## **Department of Transportation**

### **Traffic Engineering and Signals Division**

#### **EXECUTIVE SUMMARY**

A traffic analysis was conducted to evaluate the proposed Streatery implementations in Georgetown, including at the critical intersection of **Wisconsin Avenue and M Street, NW**. As part of the response to the COVID-19 pandemic, numerous Streatery locations have been proposed and implemented throughout the District to provide expanded sidewalks for pedestrians and opportunities for restaurants with outdoor seating to comply with social distancing requirements.

Figure 4 - Proposed Streatery Design for Wisconsin Avenue and M Street, NW

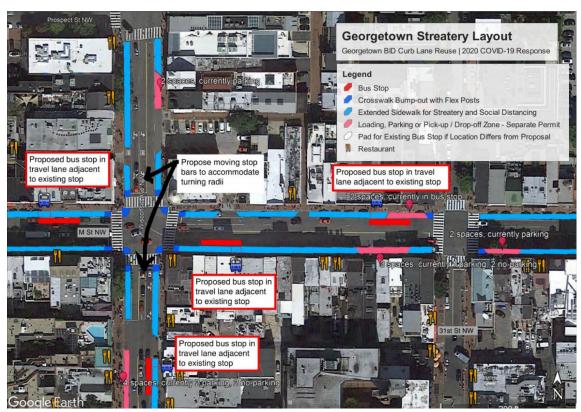
In contrast to moderate impacts to 12 of 13 locations along M Street, the reduction in curb lane capacity at the intersection of Wisconsin Avenue and M Street, NW will result in severe degradation to traffic operations due to the complexity of the signal operation involving protected only turning movements that will no longer be feasible with the removal of the curb lanes for each direction. An in-depth traffic analysis was performed for this intersection to identify feasible mitigations in order to accommodate the proposed Streateries while maintaining safe and adequate traffic operations. Additionally, field observations and fine tuning should be performed if the corridor-wide Streateries are to be implemented, and possible mitigations may require increasing signal cycle lengths in order to maintain traffic flow.

The in-depth capacity analysis demonstrates that implementing the Streatery geometry without making adjustments to the signal operation will result in significant impacts to vehicular operations. In **Alternative 1**, LOS during AM and PM peak hours is reduced from a C to an F. Significant queuing increases are expected for all four approaches that will impact upstream intersections, and many movements begin to operate over capacity.

The results of the traffic operations analysis also indicate several concerns with the Streatery design at Wisconsin Avenue and M Street, NW as proposed. First, if implemented as shown, the Streatery will require the removal of existing right turn overlaps and protected phasing, leading to safety and operational concerns. Second, the reduction in lane capacity and subsequent integration of the through movement and right turn movements into a single traffic stream will result in an unacceptable degradation of traffic operations. Third, signal phasing changes to improve operations will result in the introduction of new conflicts between turning vehicles and pedestrians.

To mitigate these concerns, it is recommended that the proposed Streatery design be modified to end the designated Streatery spaces in advance of the intersection of Wisconsin Avenue and M Street, NW on three approaches in order to maintain the exclusive right turn bays provided in the existing condition. This will address each of the above concerns by allowing the existing right turn overlaps and protected right turn phases to remain in place, allowing the existing split phasing to remain in place, and preventing a degradation of traffic operations by more than a single letter grade for each peak. Recommended turn bay lengths are provided in **Table 4**. This modified design will not impact proposed Streateries at any other signalized intersection within the proposed area, providing more than adequate space for the proposed Georgetown Streateries while maintaining safe and efficient operation of the critical Wisconsin Avenue and M Street, NW intersection.

Figure 5 - Modified Streatery Concept at Wisconsin Avenue and M Street, NW

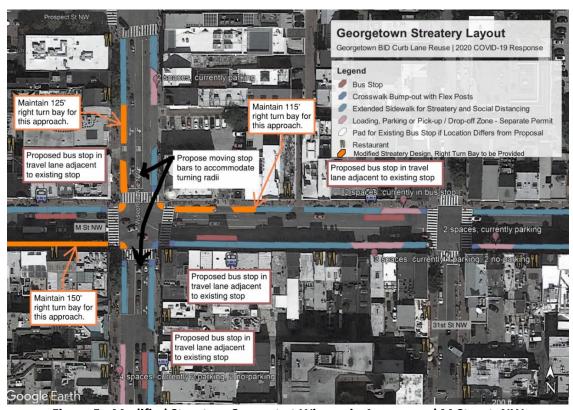
In order to balance the District's goals to provide expanded walking and dining spaces for pedestrians during the ongoing COVID-19 pandemic with the need to provide safe and efficient transportation for users of all modes at the intersection of Wisconsin Avenue and M Street, NW, a modified Streatery design concept is proposed that would maintain the existing signal operation with right-turn overlaps. This would be accomplished by ending the Streatery zones in advance of the intersection on the existing approaches with right-turn overlaps (i.e. eastbound, westbound, and southbound), thus providing exclusive right-turn bays. These modifications would require changes to or the elimination of bump-outs on three of four corners. This alternative still maintains a significant amount of curb space designated for the proposed Streatery at Wisconsin Avenue and M Street, NW and has a minimal impact on the total amount of Streatery space proposed in Georgetown. A concept showing proposed modifications to the Streatery design is shown in Figure 5 with modifications shown in orange.

While still increasing delays and queues for each approach, especially for eastbound M Street NW, the **Modified Streatery Design Alternative** mitigates the impacts of lane reductions and improves the LOS over the original Streatery concept to achieve passing grades. In fact, overall LOS is unchanged in the PM and weekend peak hours and only degrades by one letter grade in the AM peak hour.

- Right-turn overlaps are maintained through the provision of exclusive right-turn bays. This
  maintains acceptable operations for the on average 150-220 vph turning right on each of the
  westbound, eastbound, and southbound approaches during peak hours at the study intersection.
  Maintenance of the overlaps also provides dedicated protected green time for right turning
  vehicles, reducing the time that right turns are conflicting with pedestrians.

- 2. Similarly, the protected-only westbound right turn is maintained in this alternative through the provision of an exclusive right-turn bay. This provides a significant safety benefit given the extremely high pedestrian volumes in the north crosswalk.

- 3. Existing split phasing is retained, which maintains time-separation of the northbound and southbound left turns from the west and east crosswalks, respectively. This provides a significant safety benefit given the extremely high pedestrian volumes at the study intersection.

- 4. The provision of exclusive right-turn bays provides a safety and operational benefit for the affected approaches. Right turning vehicles are given a designated place to wait while yielding to pedestrians, reducing the chances that vehicles will fail to yield for pedestrians or encroach on the crosswalk to move out of the way of through vehicles. This also reduces blockages to through vehicles, which will become more critical given the reduction in lane capacity associated with the Streatery design.

Recommended exclusive right turn bay lengths were calculated based on the peak hour right turn demand to avoid spillback into the through travel lanes (which could result in undesirable weaving behaviors). These lengths are presented in **Table 4.**

Approach	AM Peak Hour Volume (vph)	PM Peak Hour Volume (vph)	WE Peak Hour Volume (vph)	Recommended Turn Bay Length (ft)
EBR	224	188	208	150
WBR	148	152	166	115
SBR	126	181	148	125
